PROJECT TITLE: RHODE ISLAND APARTMENTS ZONE ATLAS/DRAINAGE FILE # K-19/D88LEGAL DESCRIPTION: LOT 25A, BLOCK 16, MESA VERDE ADDITION

RE: REVISED DRAINAGE PLAN FOR RHODE ISLAND APARTMENTS
(K-19/D88) REVISION BLOCK DATED MAY 13, 1988

RHODE ISLAND ST. APTS. GRADING/DRAINAGE PLAN

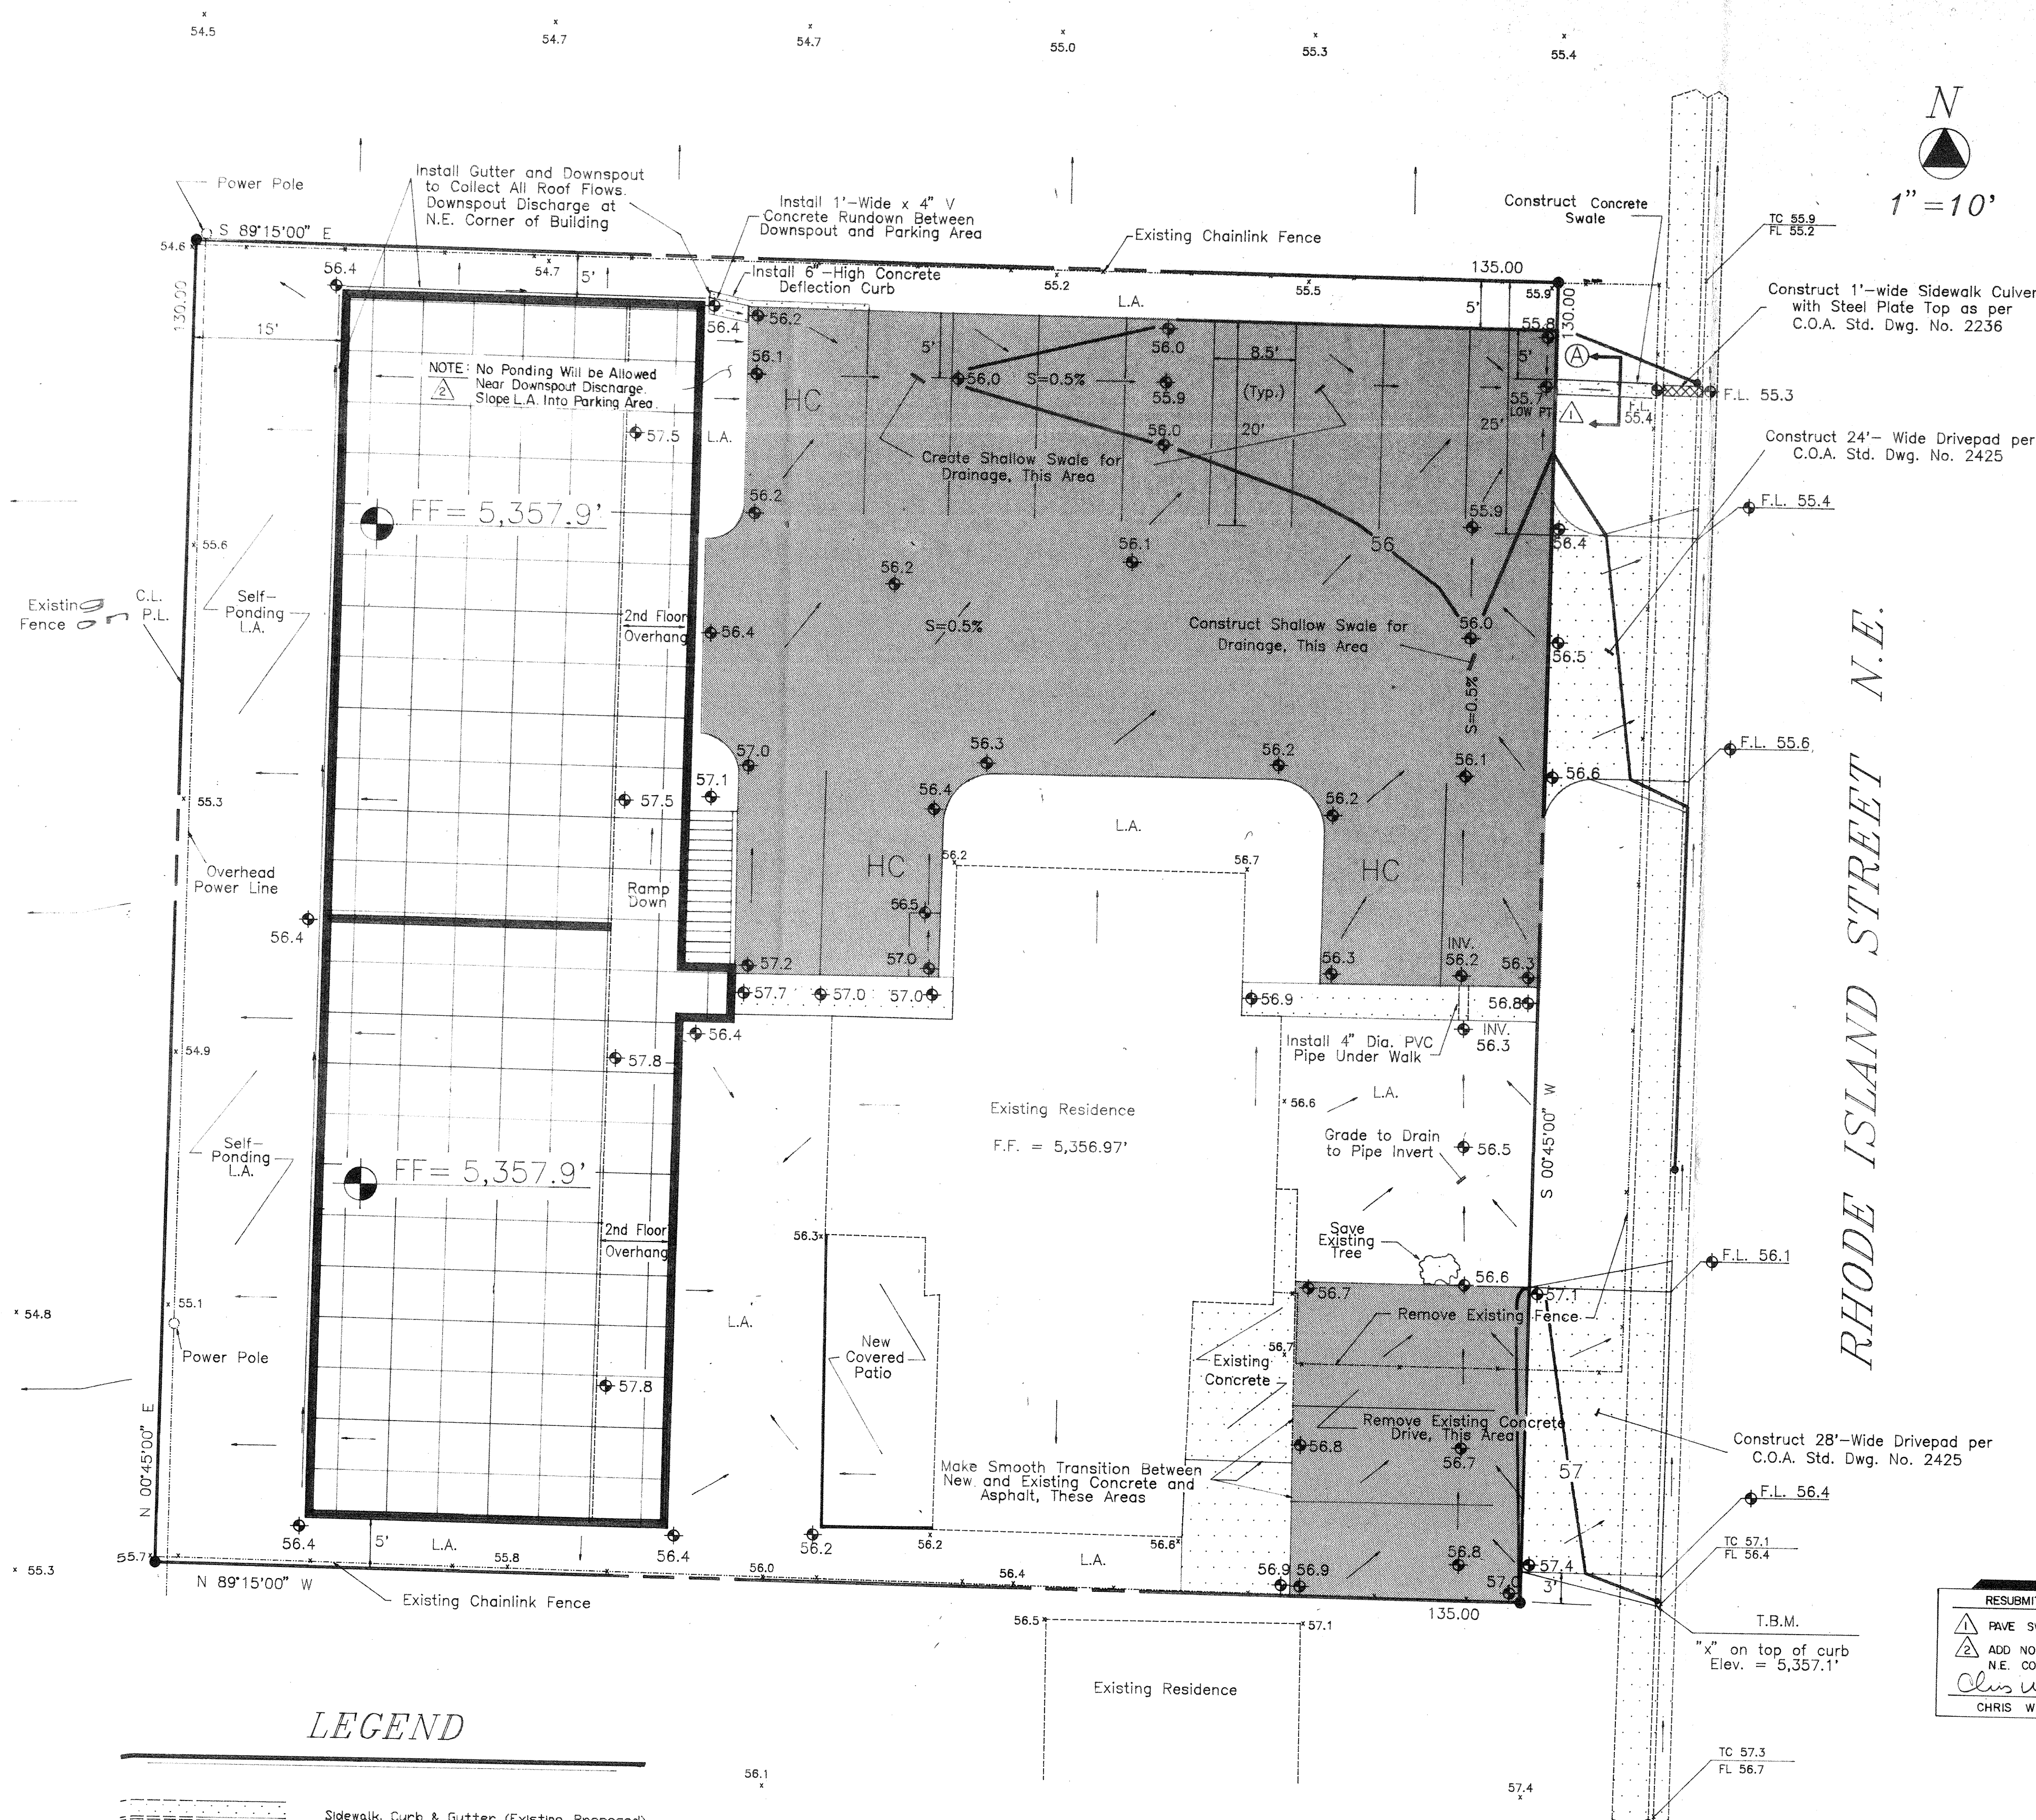
RESUBMITTAL, 5-13-88

PAVE SWALE IN CITY R.O.W.

ADD NON-PONDING NOTE AT N.E. CORNER OF BLDG.
